MTM4 BIN RDI SENTINEL PENETRATOR

Size C	CAGE Code <Cage Code>	DWG NO 1003039SCH-2.0	Rev 2.0
Monday, March 12, 2007		Scale	Sheet 1 of 1

MTM4 BIN RDI SENTINEL PENETRATOR

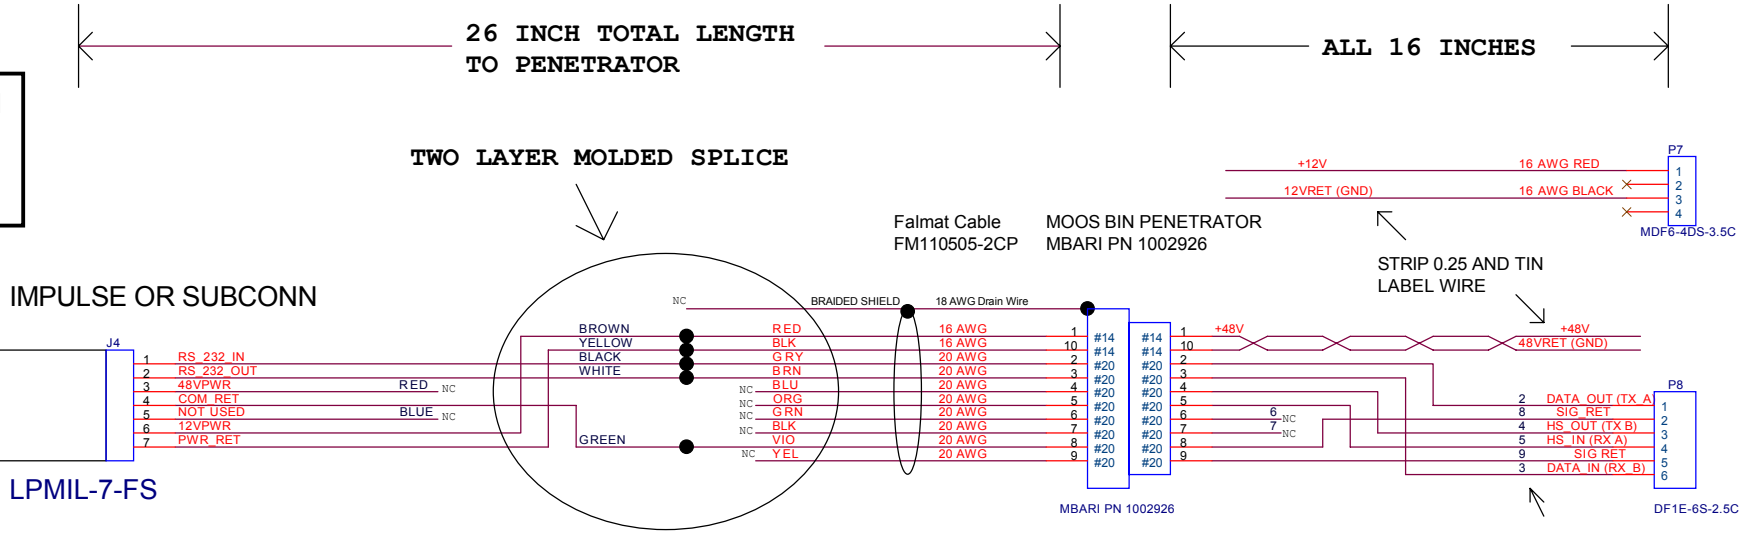
NOTE: THIS CABLE VERSION HAS 48V ON ADCP PIN 6 AND ADCP INTERNAL WIRING MUST BE MODIFIED TO MATCH! MRC 05JUN06.

NOTE: THIS VERSION IS IN ERROR AND CAN ONLY BE USED WITH MODIFIED ADCP INTERNAL WIRING. UNMODIFIED ADCP AND ALL FUTURE BUILDS MUST USE UPDATED WIRING VERSION 3.0. MRC 05JUN06.
